1988 - 1990 Corvette: Service Bulletin: Power Steering Shudder / Groan

Subject: POWER STEERING SHUDDER/GROAN INSTALL P/S COOLER & HOSE

Model and Year: 1988-90 CORVETTE WITH 5.7L ENGINE

Bulletin Number: 90-376-3B - (10/25/1990)

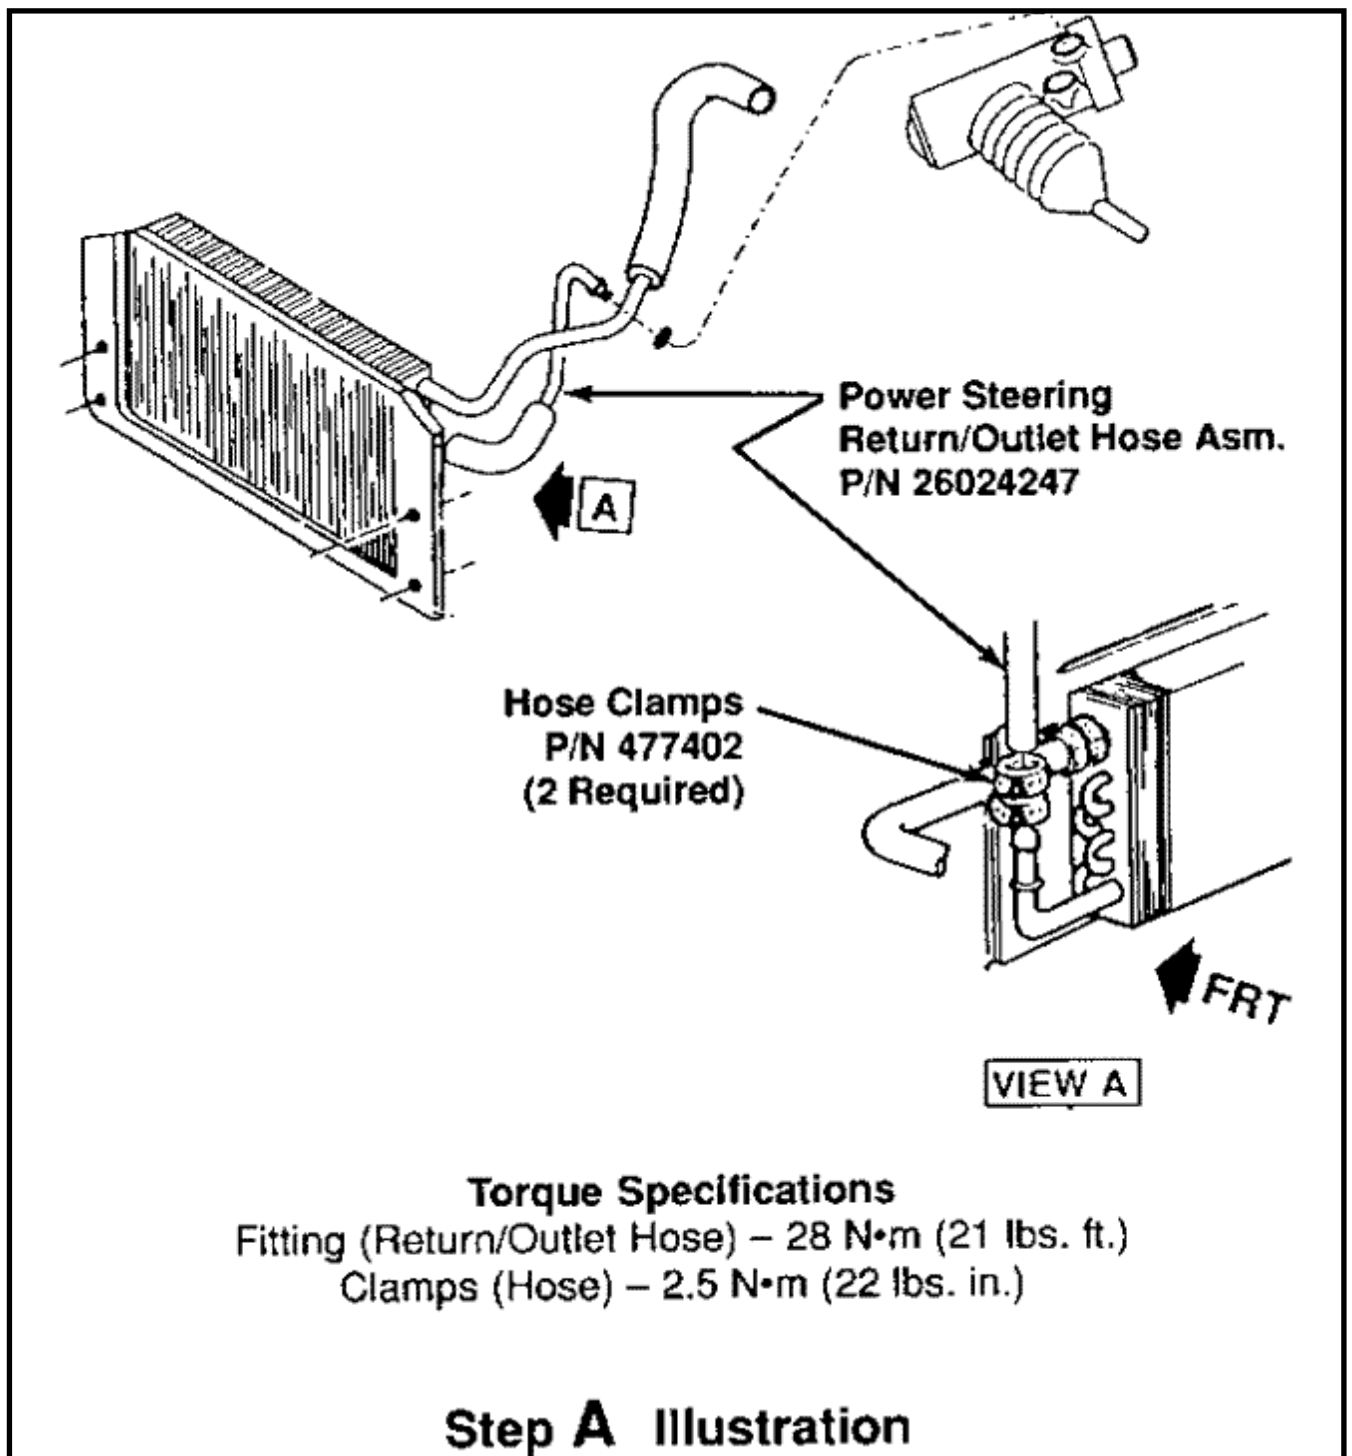
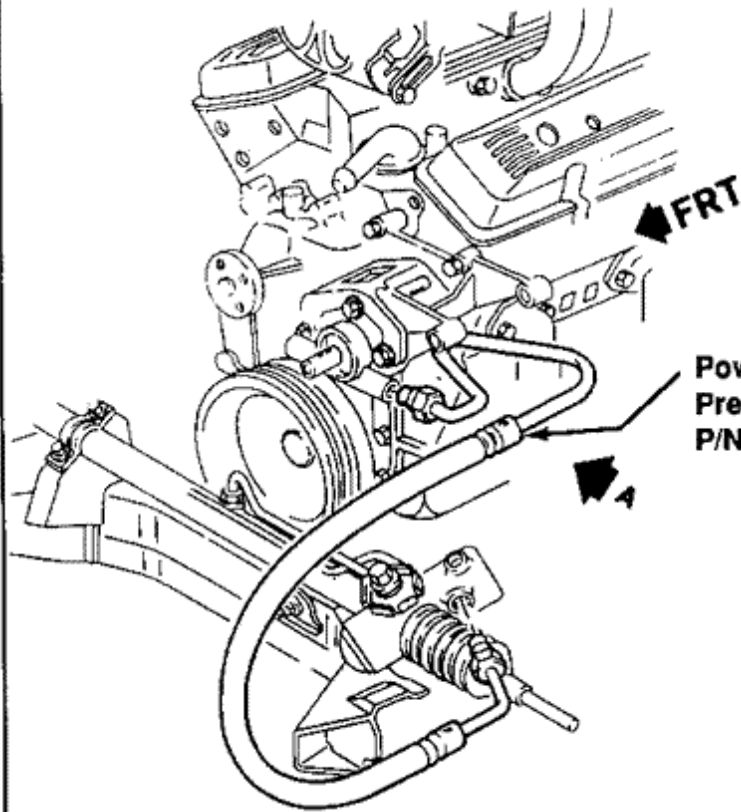
On applicable 1990 vehicles as designated by VIN breakpoints indicated in step matrix, replace existing power steering gear.

Step B Illustration

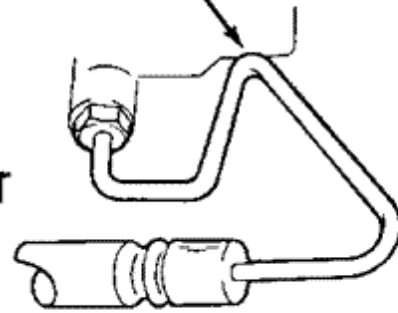
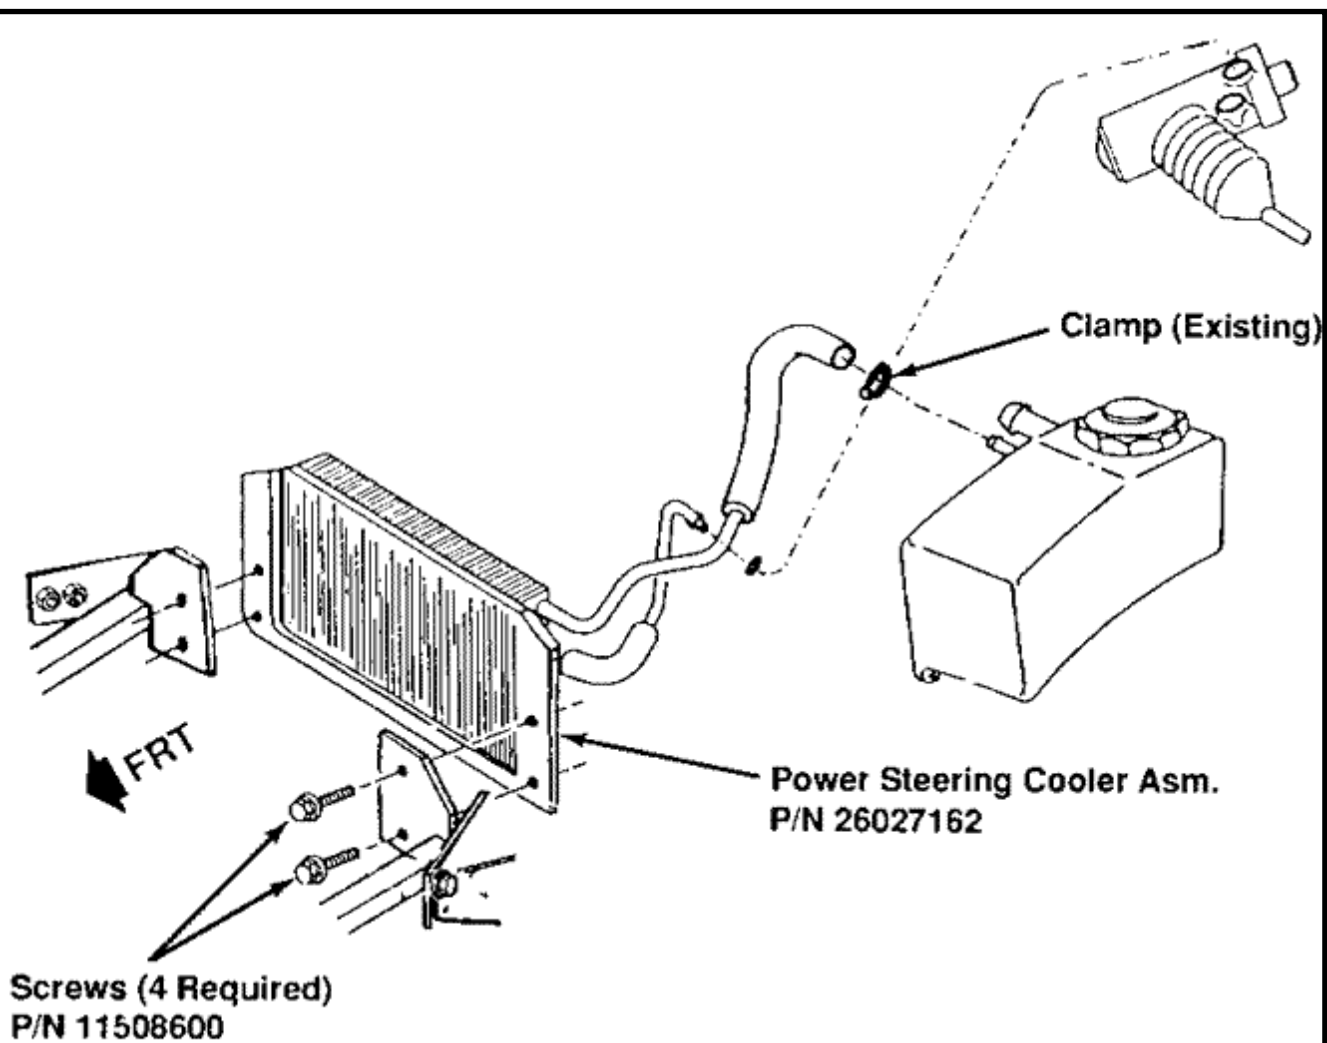
Replace existing pressure/inlet hose (pump to steering gear) with new assembly with internal tuner cable.

Power Steering
Pressure/Inlet Hose Asm.
P/N 262027177

Pipe at Pump End of
Hose Asm. is to be
Against Lower Corner
of Pump

Torque Specifications
Fittings (Pressure/Inlet Hose) – 28 N·m (21 lbs. ft.)

Step C Illustration (1990 Vehicles)

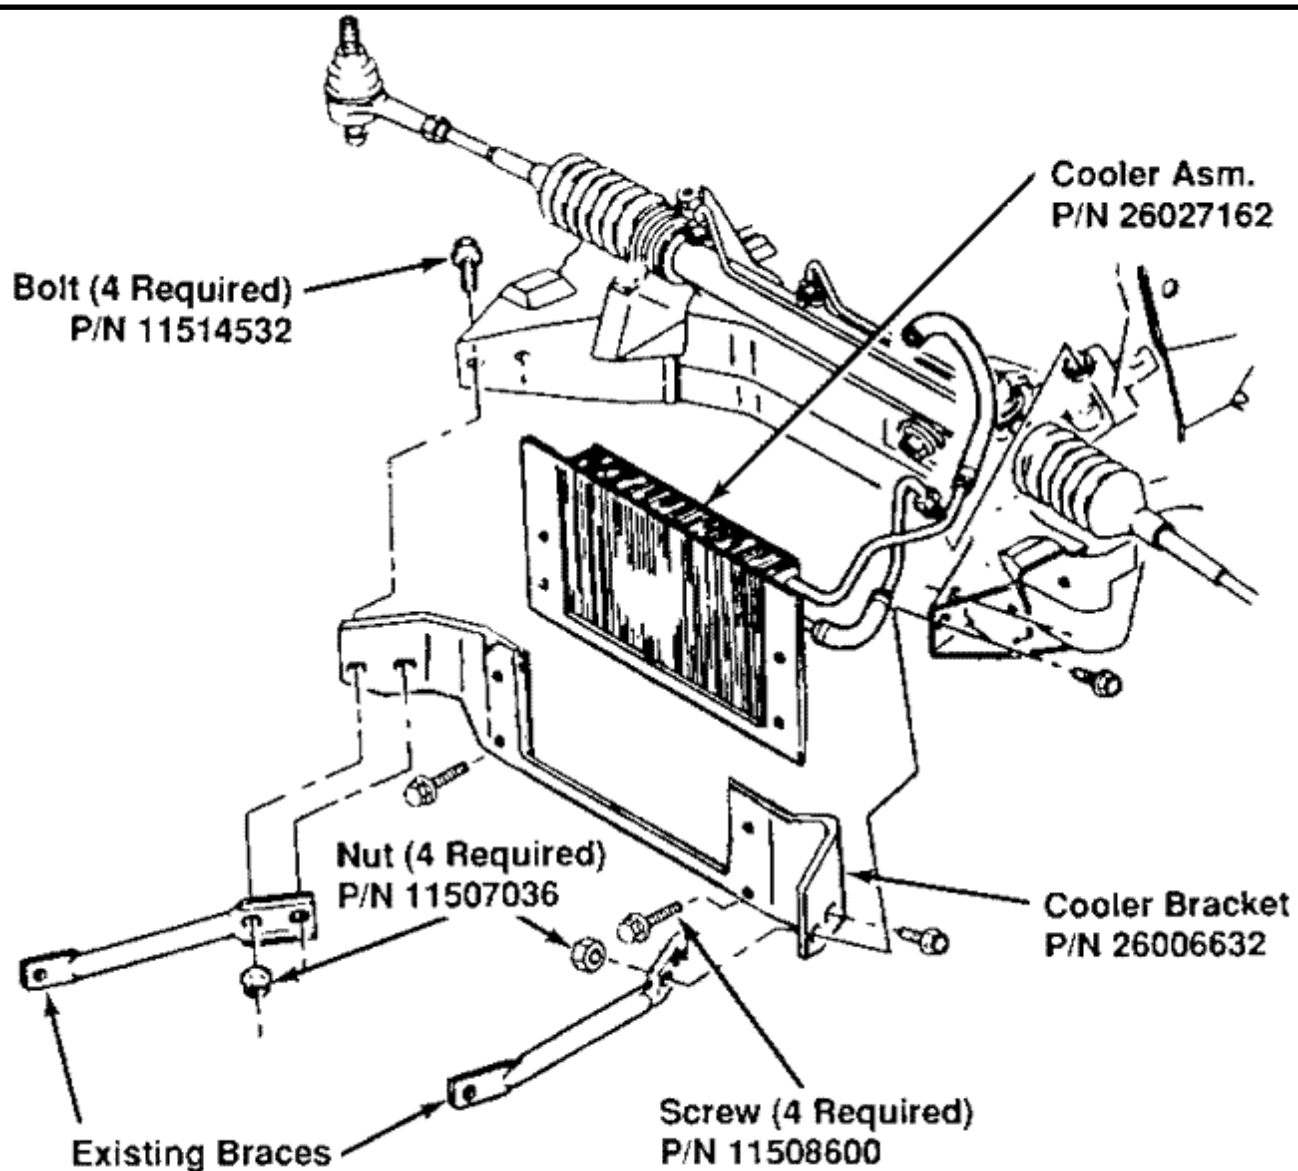
Replace existing power steering loop/pipe cooler with finned cooler that includes return hose with tuner cable.

Torque Specifications

Fitting (Return/Outlet Hose) – 28 N•m (21 lbs. ft.)

Clamp (Reservoir Hose) – 2.5 N•m (22 lbs. in.)

Screws (Cooler/Bracket) – 10 N•m (89 lbs. in.)
